Subject: UniStar Nuclear Energy, NRC Docket No. 52-016  
Response to Request for Additional Information for the  
Calvert Cliffs Nuclear Power Plant, Unit 3,  
RAI No. 58, Seismic Design Parameters  
RAI No. 63, Seismic Subsystem Analysis  
RAI No. 65, Seismic System Analysis

**Response to NRC Request for Additional Information  
RAI No. 58 - Seismic Design Parameters, and  
RAI No. 65, Seismic System Analysis  
Calvert Cliffs Nuclear Power Plant Unit 3**

**Figure 1**

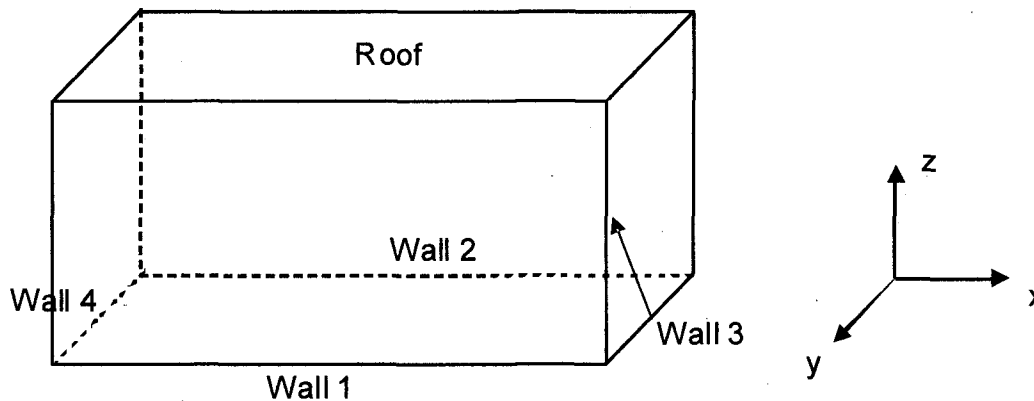
In FSAR Section 3.7.2.6 on page 3.0-40, it states that separate manual calculations, using the equivalent static analysis method are performed to determine the structural response of the site-specific Ultimate Heat Sink Electrical Building in each of the three directions. On page 3.0-35, it states that 0.5 g acceleration is used in all directions. Describe in the FSAR the manual calculations that were used, how the structural response was obtained, and provide examples of how the three components of earthquake motion are combined comparing the results to those of the 100-40-40 rule presented in RG 1.92, Revision 2, or justify an alternative. Also describe how the forces and moments are determined to design the individual elements (walls and slabs) of this structure, or justify an alternative.

The manual calculations pertaining to the seismic responses of the Ultimate Heat Sink (UHS) Electrical Building (EB) are described below using a simplified structure (Figure 1), which has four exterior walls (interior walls not shown for clarity), and a roof slab. The manual calculations include calculation of the equivalent static loads, torsional effects due to both inherent and accidental torsion, and calculation of the design forces and moments.

Under this load combination, the structural responses in Wall 1 (see Figure 1), for example, are calculated in Table 1, where  $H_x$  and  $H_y$  represent the dynamic soil pressure load associated with  $E_x$  and  $E_y$ .

<b>Response</b>	<b>Loads</b>	<b>Calculation Method</b>
In-plane (i.p.) shear	$E_x, H_x$	Wall 1 and 2 each carries half of the lateral load in x direction so that the in-plane shear in Wall 1 is $0.5(\max(E_x, H_x))$ . Additional in-plane shear due to inherent and accidental torsional effects is also added.
In-plane moment	$E_x, H_x$	Conservatively, in-plane moment is calculated as $0.5(\max(E_x, H_x))$ multiplied by height of Wall 1.
Out-of-plane (o.o.p.) shear and moment	$H, E_x, H_x, 0.4E_y, 0.4H_y$	Considering a section of unit width, which behaves like a beam supported at the top and bottom edges, the o.o.p shear and moment are calculated using beam theory. Dynamic soil pressure or seismic inertia load, whichever governs, is added to the force from the static soil pressure load $H$ to maximize the o.o.p. response.
Normal force (compression or tension)	$D, L, 0.4E_z$	Normal force is equal to the sum of dead load, live load, and vertical seismic inertia load associated with the wall and tributary roof slab.
